BULLETIN NUMBER
SB25-J-001

CHARGE AIR COOLER (CAC) HOSE CLIP INSTALLATION

AFFECTED VEHICLES

- 2022-2026MY Isuzu F-Series Vehicles
With a production date prior to 8/4/2025

Figure 1

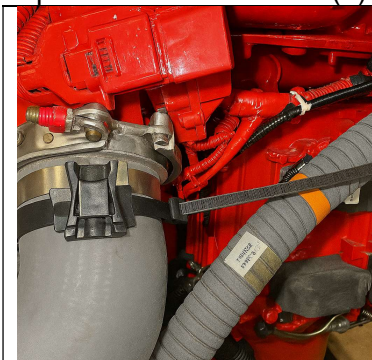
- After completing the installation of the new CAC hose per the WSM, place the hose clip directly below the hose clamp and secure with one (1) zip tie as shown in Figure 1.

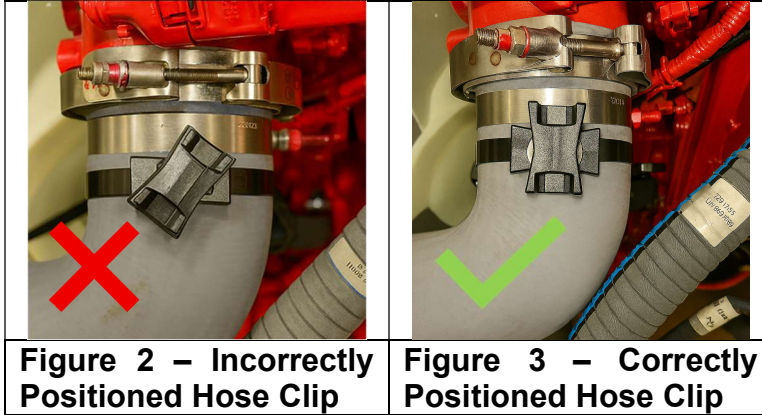
2. Trim the excess zip tie.
3. Turn the hose clip so that the clip is facing up. See Figures 2 and 3.

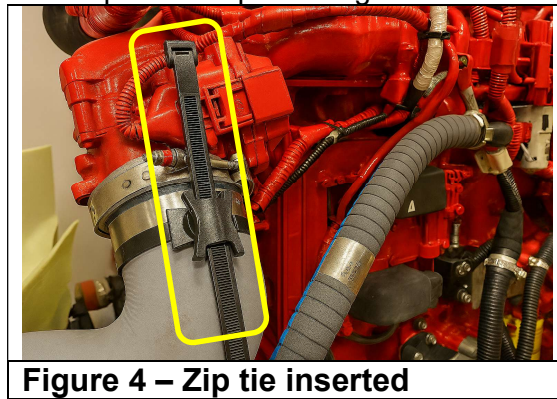
4. Insert the zip tie into the top of the clip. See Figure 4.

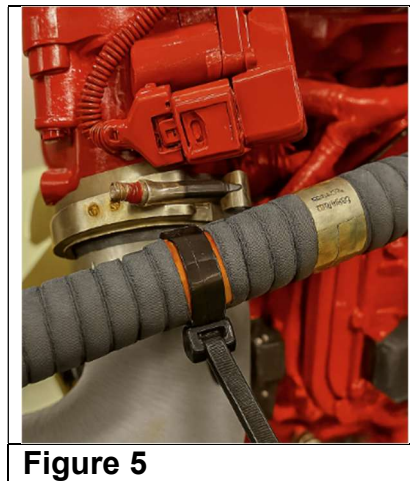
5. Lay the compressor inlet hose on top of the hose clip installed in Step 4 and tighten the zip tie. See Figure 5.
